Quality Control Check Report. Stage: After Finishing Stage II (Apartments)

Flat No	H-302	Other	—	Sl. No.	43083
Company	MRM-(LLP)	Project	GMR	Phase	—
Prepared by	Abhishek Gaudar	Sign	Abhishek	Date	13-08-24
Project Manager	Srinivas	Sign	② Srinivas	Date	13-08-24
Previous stage report no.	43082	Report filed and signed by PM		☒ Yes ☐ No	
Checked By MD on		MD Sign		For filling	☐ Yes ☐ No

Quality Control Check Report. Stage: After Plumbing & Electrical (Apartments)

Description	Direction	Owners & Developers :	Date :	16.09.20	Promoted by
PLUMBING PLAN-1360 Sft (A2-TYPE)		Modi Reality Mallapur LLP	Prepared By :	Jayapradha	Modi Properties Pvt Ltd
		Project Name & Phase :	Approved By :	Soham Modi	
		Gulmohar Residency	Scale :	N.T.S	Phone:+91-40-66335551

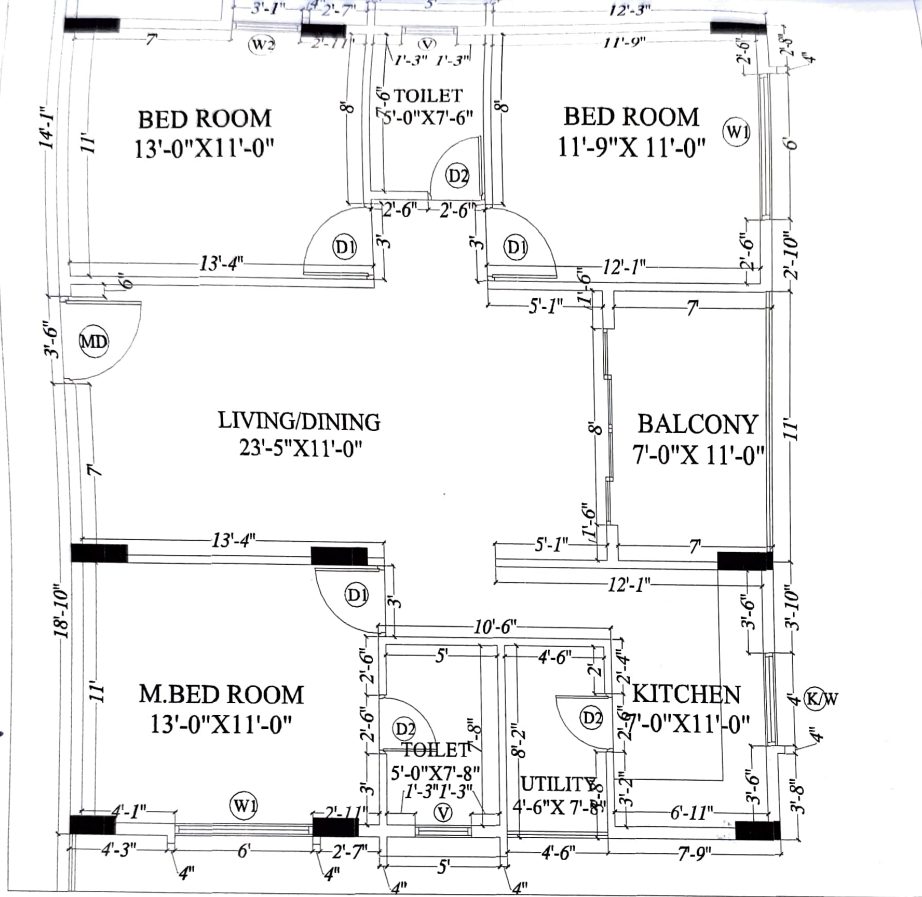
HEALTH FAUCET
	ANGLE VALVE
	NANI TRAP
	3" RAIN WATER PIPE
	GEASER POINT
	WALL MIXTURE
	TAP / LONG BODY
